Access Compliance Report

Public Rights-of-Way

(Curb Ramps)

Intersection ID: 49254	Main Street: OAKBURN_DR	Cross Street: LEGATO_LN	Location: NW
ADA ID: E8791A97E6BF	Ramp Type: PerpDiag	Initial Pass/Fail: Fail	Overall Compliance: No
Severity Score: 10			
Codes/Mitigation Info/Possible Solution		Field Measurements/Component Compliance

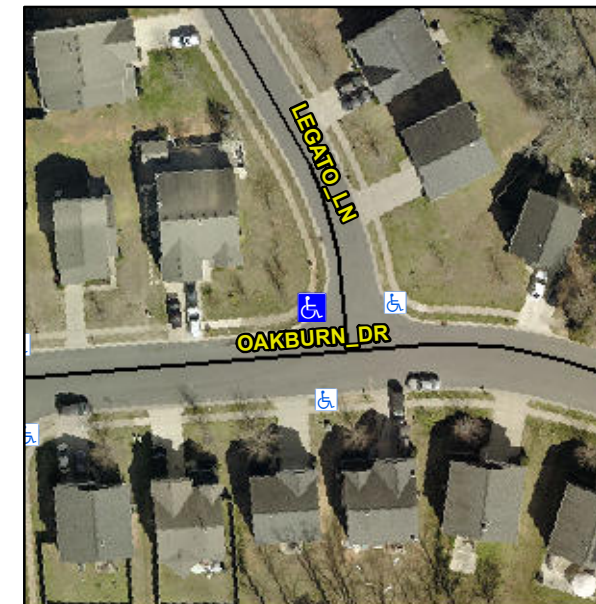
PROW/ADA:

Not Found, R304.5.1, R304.5.3

Compliance	Description	Data	Compliance	Description	Data
N/A	Ramp Length (in)	47.0	Yes	Ramp Slope (%)	7.3
No	Ramp Width (in)	47.0	No	Ramp XSlope (%)	3.2
N/A	Flare Type LT	N/A	N/A	Flare Type RT	N/A
N/A	Flare Slope LT (%)	N/A	N/A	Flare Slope RT (%)	N/A
N/A	Flare Traversable LT?	N/A	N/A	Flare Traversable RT?	N/A
N/A	Landing Length (in)	N/A	N/A	DWS Provided?	N/A
N/A	Landing Width (in)	N/A	N/A	DWS Contrast?	N/A
N/A	Landing Slope (%)	N/A	N/A	DWS Length (in)	N/A
N/A	Landing X Slope (%)	N/A	N/A	DWS Full Width?	N/A
N/A	Landing Curb? (Y/N)	N/A	N/A	DWS Offset (in)	N/A
N/A	Shared Landing?	N/A			
N/A	Gutter Ponding?	N/A	N/A	Gutter Slope (%)	N/A
N/A	Gutter Lip Ht (in)	N/A	N/A	Gutter X Slope (%)	N/A
N/A	Painted X Walk1?	No	N/A	Painted X Walk2?	No
	X Walk 1 Direction	To S		X Walk 2 Direction	To E
N/A	X Walk 1 Width (in)	N/A	N/A	X Walk 2 Width (in)	N/A
	X Walk 1 Slope (%)	2.5		X Walk 2 Slope (%)	2.6
	X Walk 1 X Slope (%)	4.6		X Walk 2 X Slope (%)	2.0

Remove & Replace Curb Ramp With Two New Directional Ramps or Equivalent.
